METROPOLITAN GOVERNMENT OF NASHVILLE AND DAVIDSON COUNTY

STAFF RECOMMENDATION 1907 Benjamin Street November 19, 2014

Application: New construction-infill and outbuilding
District: Eastwood Neighborhood Conservation Zoning Overlay
Council District: 06
Map and Parcel Number: 08302036200
Applicant: Van Pond Architect, PLLC
Project Lead: Paul Hoffman, paul.hoffman@nashville.gov

Description of Project: The applicant proposes construction of a new residence on this vacant lot.

Proposed Site Plan
 1/20" = 1'-0"

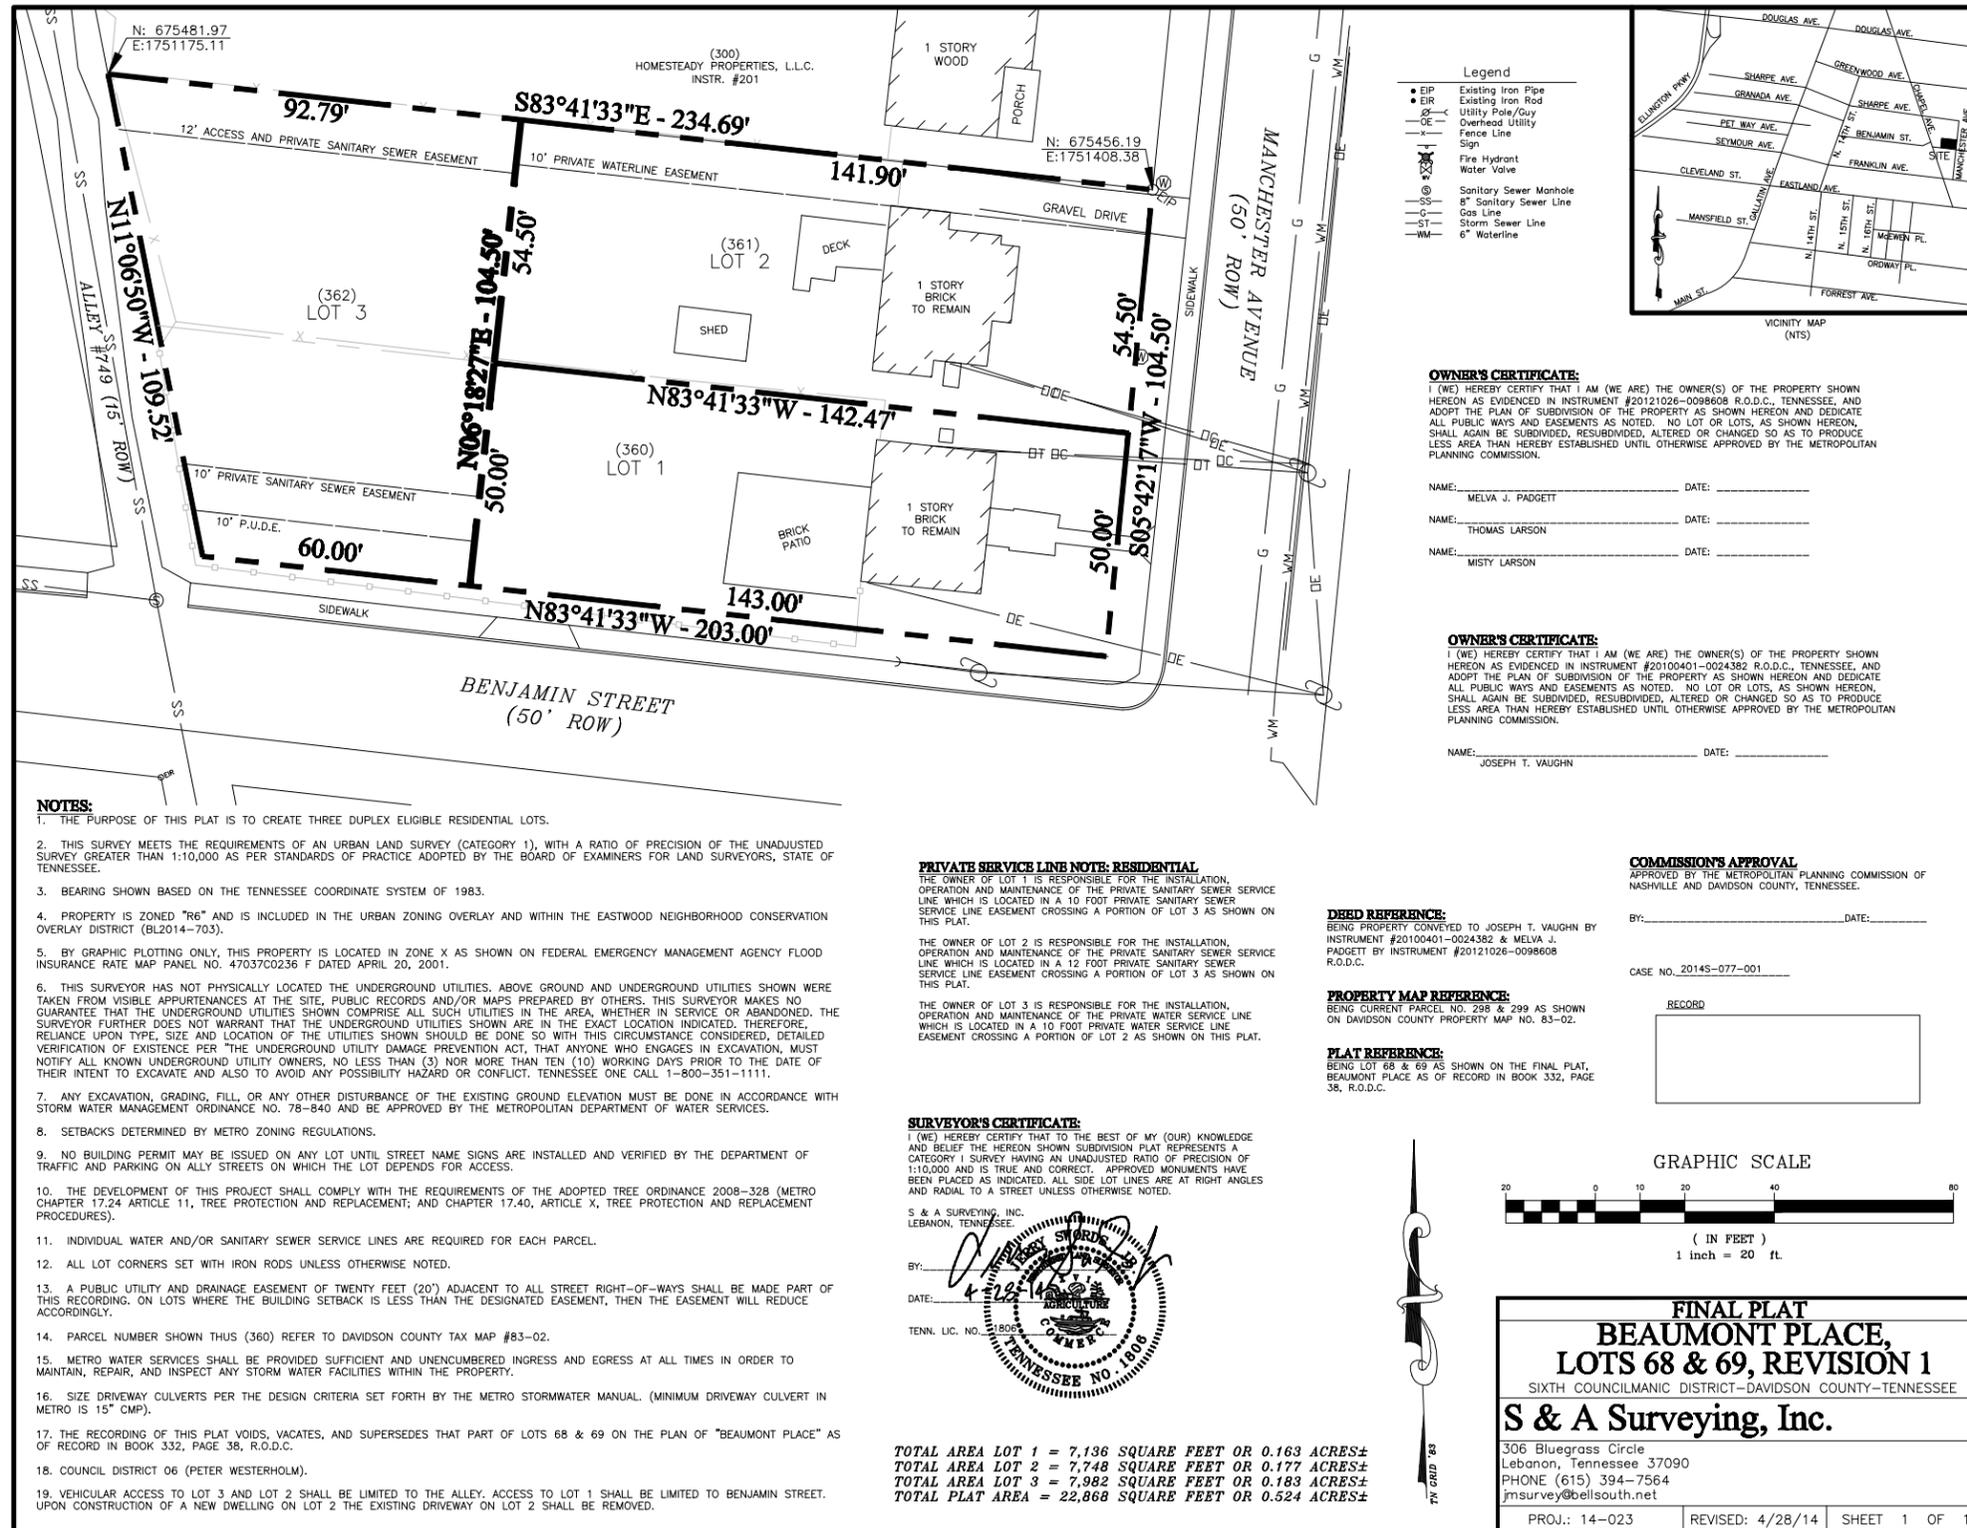
Outbuildings: The outbuilding will be twenty-four feet (24') square, for a footprint of five hundred seventy-six square feet (576 sq. ft.). It will have a ridge height of twenty-one feet (21') and eave height of eight feet (8'); these dimensions are subordinate to the principal building's fourteen foot (14') eave height and overall height of twenty-six feet, eight inches (26'8") from finished floor. The proposed outbuilding meets the guidelines for height and scale. The materials, character and details will be the same as the proposed house. The roof is a pyramidal shape, which is unusual, but is an appropriate roof form historically, and has the same 12/12 pitch as the roof of the house. The windows and doors are the same type as those on the house, and they are appropriate to the style of the house. The siding and trim will be smooth-faced fiber cement trim and siding with five inch (5") reveal, also matching the house. The outbuilding's location is close to the alley, at the rear of the lot. Its setbacks will be five feet (5') from the side property line, and twenty feet (20') from the rear.

The location currently does not meet II.B.1.h.2 of the design guidelines:

· There should be a minimum separation of 20' between the principal structure and the DADU or outbuilding.

Staff recommends that the location of the outbuilding be moved farther to the rear of the lot in order to meet this portion of the guidelines.

1. The finished floor height shall be consistent with the finished floor heights of the adjacent historic houses, to be verified by MHZC staff in the field;
2. Staff approve the windows, doors, roof color and a brick sample;
3. A window opening be added to the north elevation;
4. The wall dormer on the north side be redesigned as a roof dormer;
5. The outbuilding be relocated to be twenty feet (20') from the house.

Proposed Side Elevation (North)

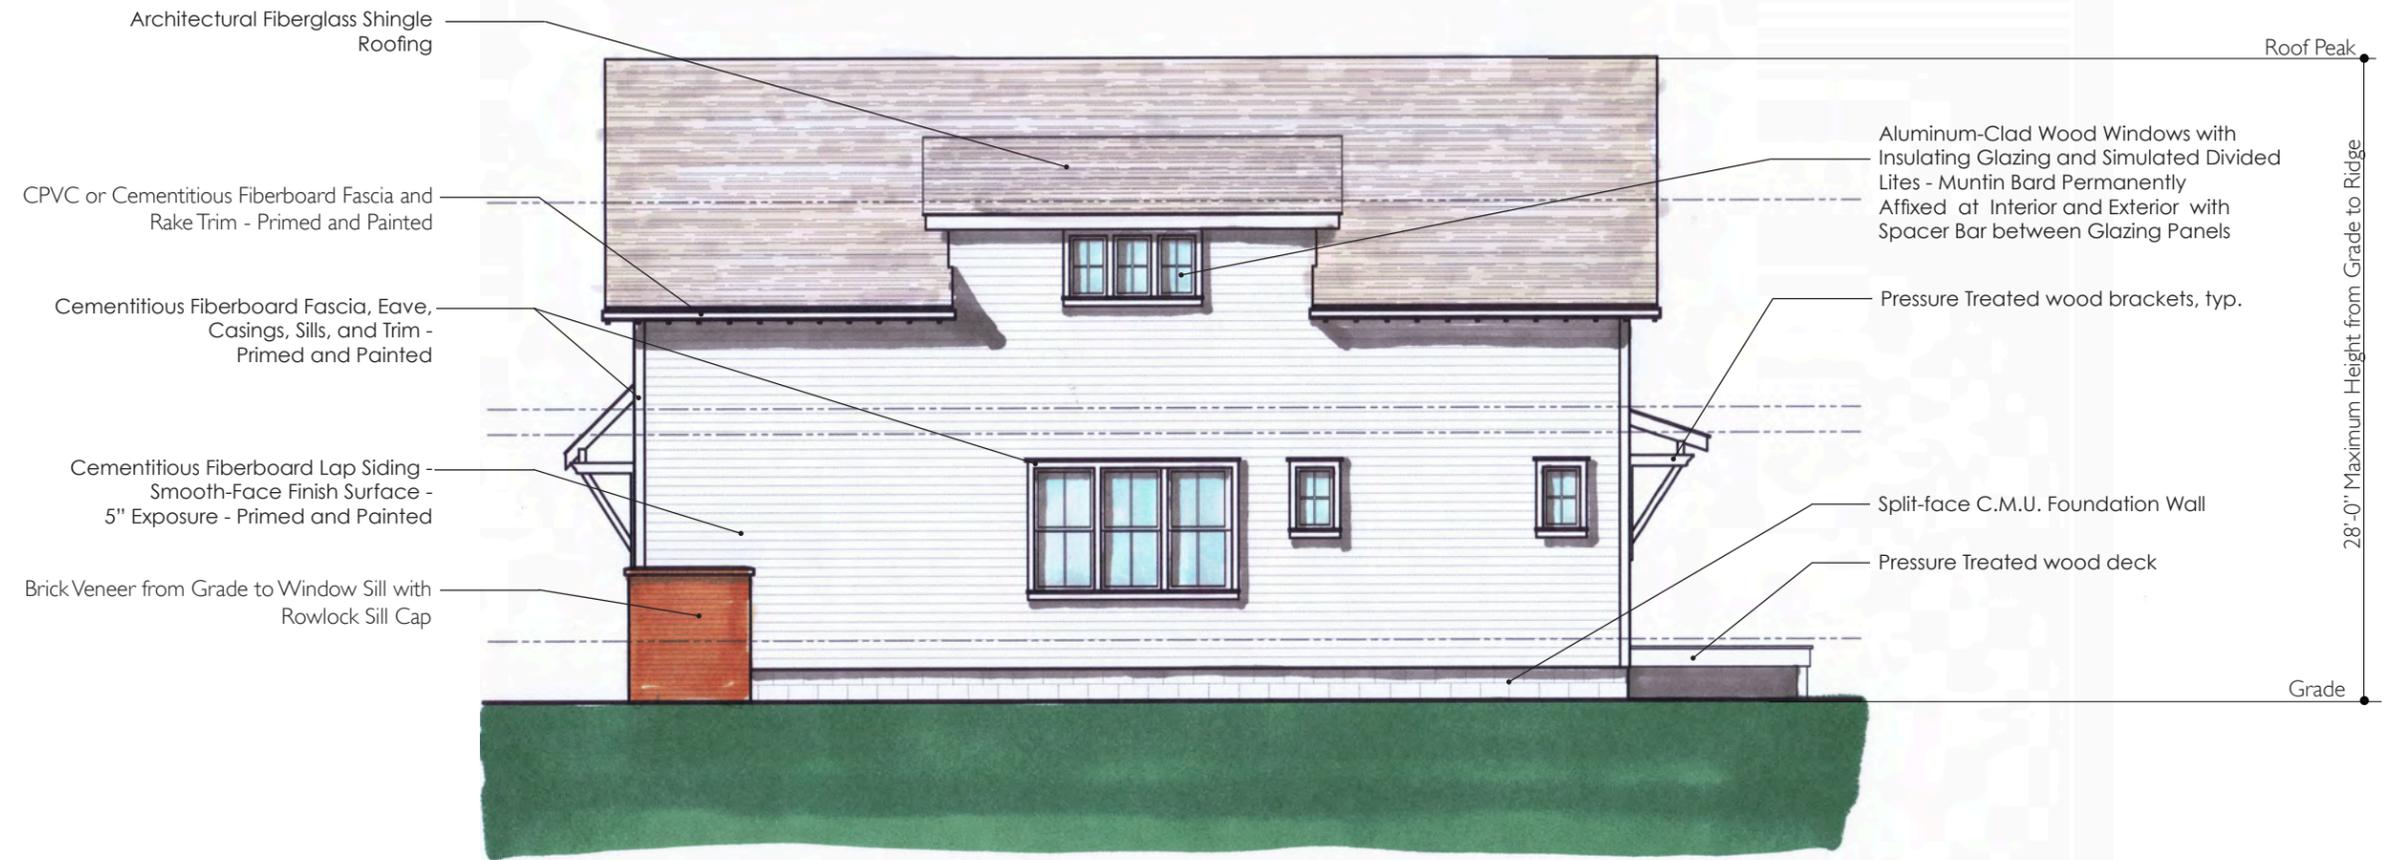
Roof form: The house has a complicated roof form. The primary roofs are gabled with 12/12 pitch. The north side elevation includes a wall dormer. As wall dormers are not typical in the historical context, Staff requests this be redesigned to be a roof dormer that is at least two feet (2') off the ridge and two feet (2') off the wall below. Meeting this condition, the proposed structure meets section II.B.1.e.

Proportion and Rhythm of Openings: The windows are generally vertically-oriented windows, meeting the historic proportions of openings. There is an expanse of sixteen feet (16') of the north side elevation without an opening, which exceeds the guidelines of an opening every eight to thirteen feet (8-13'). Staff recommends a window opening be added in this area. With this condition, the project's proportion and rhythm of openings will meet Section II.B.1.g.
